NOTICE OF DECISION

CLASS 3 SITE PLAN REVIEW / CLASS 2 ADJUSTMENT / CLASS 2 DRIVEWAY APPROACH PERMIT / CLASS 1 DESIGN REVIEW CASE NO.: SPR-ADJ-DAP-DR23-12

SUMMARY: A proposal for a new 67-unit multi-family housing development.

LOCATION: 1900 Block of Linwood Street NW

SHEET TITLE: SITE LAYOUT PLAN

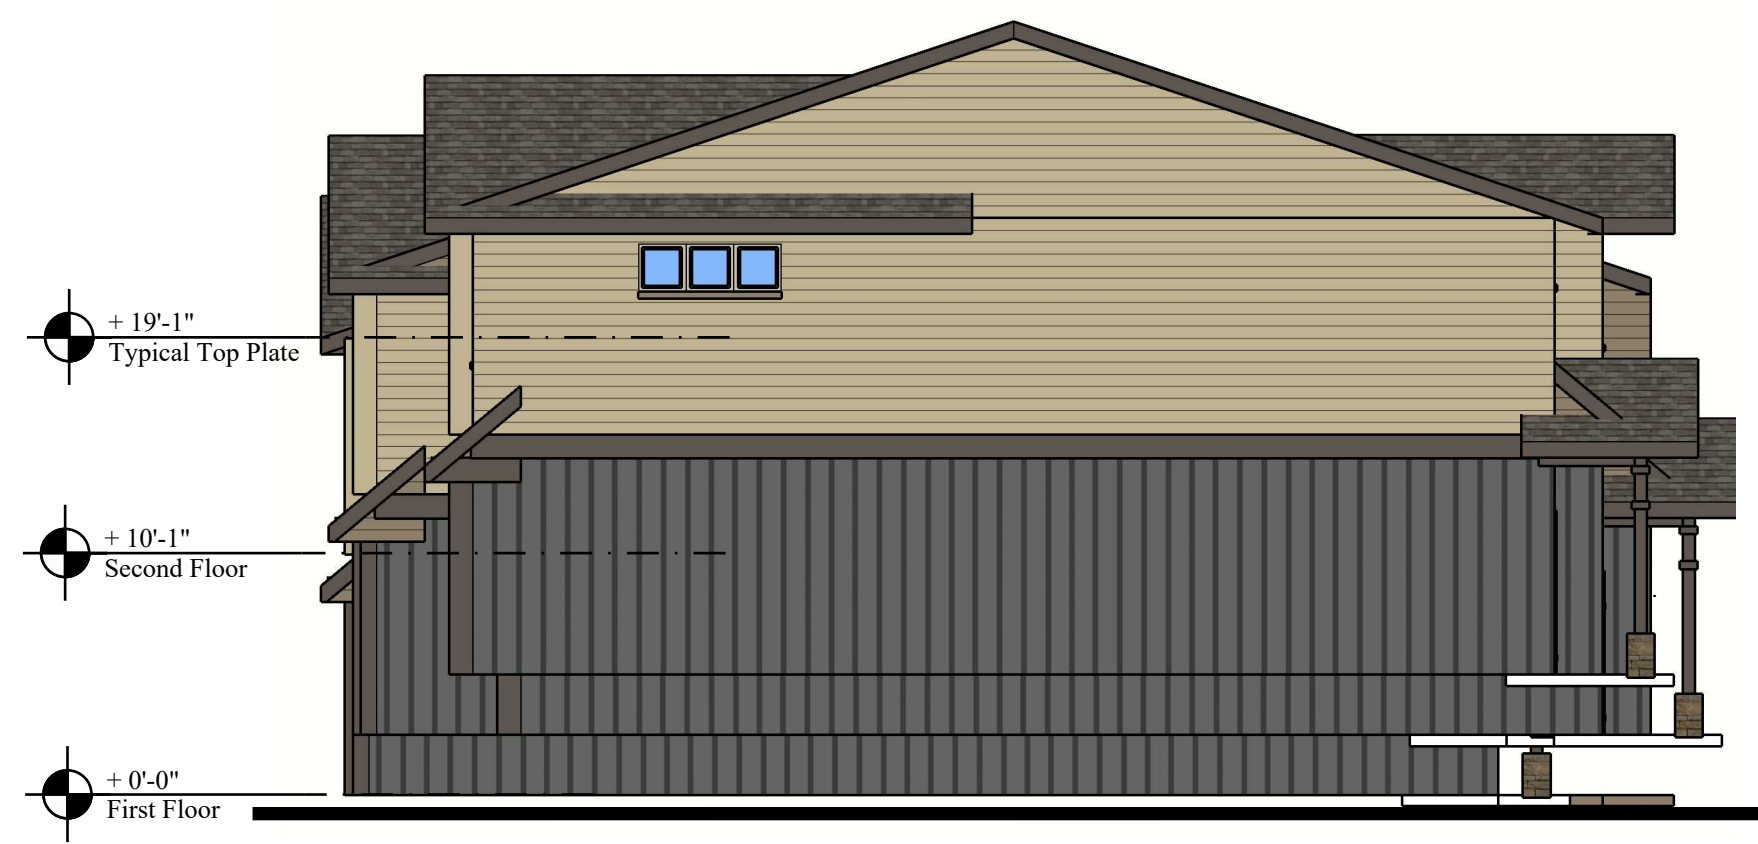
Finding: Buildings 9, 10, and 11 are setback 10 feet from the northern property line abutting the RM-II zoned property, thereby meeting the standard. Building 13 is setback 20 feet from the west property line; however, the plans include a drive aisle that dead-ends at the west property line, and does not provide the minimum 10-foot setback for a vehicle use area. As such, the following conditions applies:

Finding: For two-way circulation, the width of an aisle dedicated to standard-size parking spaces shall be a minimum of 24 feet. The applicant's plans indicate a one-way aisle of 18-feet wide and 24-foot-wide drive aisles for two-way circulation throughout the development; except for the northern drive-aisle adjacent to Buildings 9, 10, and 11, where a 20-foot drive-aisle is proposed. The applicant has requested a Class 2 Adjustment to the minimum drive-aisle width required for two circulation for the northern drive aisle. Findings for the adjustment are included in Section 7 of this report.

Finding: The applicant has submitted a preliminary landscape plan that indicates 78,744 square feet of total landscaped area for the development site. However, the landscape plans do not indicate the specific landscaping proposed in required setbacks based on a 10-foot setback abutting residential properties to the north, west, and south property lines. Based on the dimensions of the property, the landscaping for required setbacks should be at least 27,520 square feet ($[612 \times 10] + [220 \times 10] + [198 \times 10] + [242 \times 10] + [740 \times 20] = 27,520$), requiring a minimum of 1,376 plant units ($27,520 / 20 = 1,376$). Of the required plant units, a minimum of 550 plant units shall be trees ($1,376 \times 0.4 = 550.4$). The applicant has provided a preliminary landscaping plan which shows the areas which are to be landscaped, but does not indicate the total number of plant units or trees within all required setbacks. As such, the following condition applies:

There is an existing public sanitary sewer main on the subject property within an easement that serves upstream parcels. The applicant's plans show buildings over the existing public main and that the public main will be relocated. The easement for the existing main was dedicated by Partition Plan No. 2012-0012. The existing main shall be relocated and the easement shall be vacated pursuant to the process described in SRC 255.065. The new main shall be constructed in an alignment approved by the Public Works Director and a new easement shall be dedicated by separate document. The sanitary sewer main relocation and easement width shall meet current Public Works Design Standards. As such, the following conditions apply:

- Condition 3:** Prior to building permit approval, the vehicle use area abutting RS-zoned property to the west shall be setback a minimum of 10 feet, with Type C landscaping, or obtain approval of a Zoning Adjustment.

- Condition 5:** At the time of building permit review, the applicant shall dedicate one parking space adjacent to each dead-end turnaround area by striping the parking space and installing no parking signs to provide safe and convenient vehicle maneuvering, pursuant to SRC 806.035(f), or obtain approval of a Zoning Adjustment.

- Condition 7:** At the time of building permit review, the applicant shall provide an updated landscape plan demonstrating how the development site meets Type C landscaping within the required setbacks along the north, west, and south property lines, by providing a minimum of 1,376 plant units, with 550 of the plant units being trees, and including a minimum six-foot-tall sight-obscuring fence.
